KENWOOD

SERVICE BULLETIN AMATEUR RADIO

SUBJECT
TH-26A INTERNAL BIRDIES

DATE
08/08/90

FIGURE 2

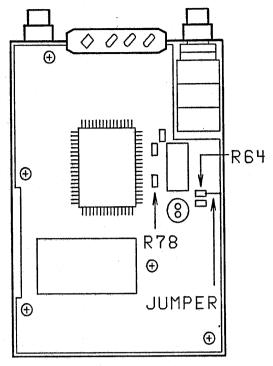
- 1. Disconnect the battery pack and antenna.
- 2. Remove the three case screws and four battery plate screws. Figure 1
- 3. Lift the front panel from the body of the transceiver.
- 4. Do not lose the rubber cover for the DC IN jack.
- 5. Locate R78 on the Control board inside the front panel. Figure 2
- 6. Replace R78 with a 6.8K ohm chip resistor.
- 7. Install a jumper wire from R64 to the mounting plate behind the PTT switch. Figure 2

REMOVE L12

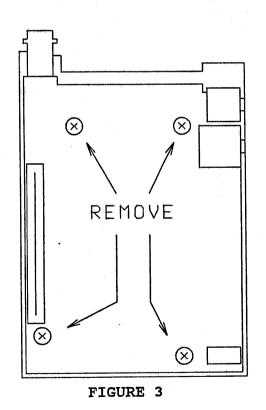
- 12. Remove the four screws from the TX/RX (B/2) board. Figure 4
- 13. Remove the three black screws from the back panel that secure the antenna BNC connector.
- 14. Carefully lift the TX/RX (B/2) board off the back panel.
- 15. Locate L12 on the TX/RX (B/2) board. Figure 4
- 16. Replace L12 with a 1mH inductor.
- 17. Assemble the transceiver.
